ADDENDUM NO. 1
SEWER SYSTEM IMPROVEMENTS
CONTRACT 17-01
SOUTH WASTEWATER TREATMENT PLANT
AERATION BASIN IMPROVEMENTS
HENDERSON WATER UTILITY
HENDERSON, KENTUCKY
WAUFORD PROJECT NO. 2077

Date of Addendum: Monday, July 3, 2017

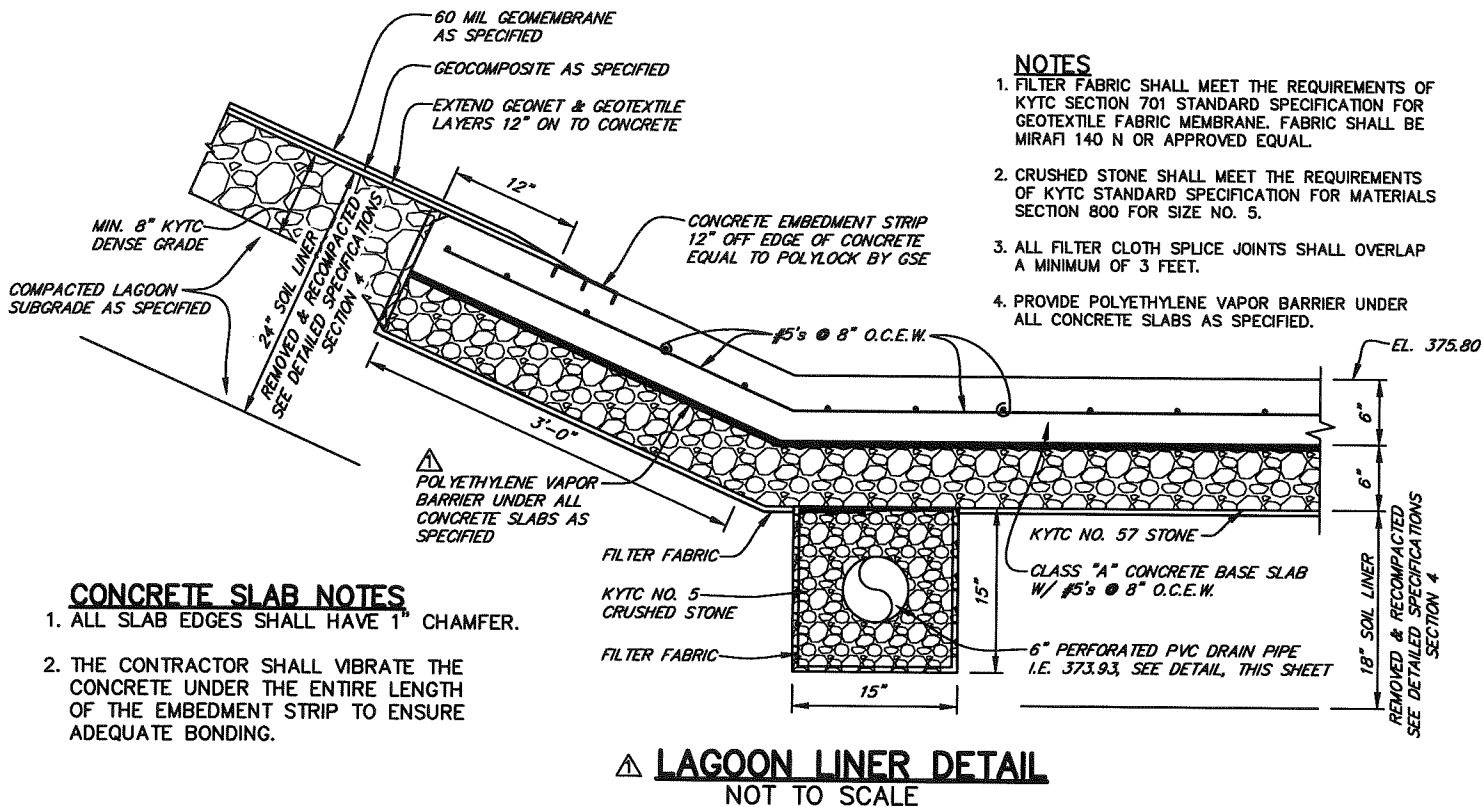
10. Plans, Sheet 5:

Modify as shown on the two (2) attached 8 ½" x 11" sheets.
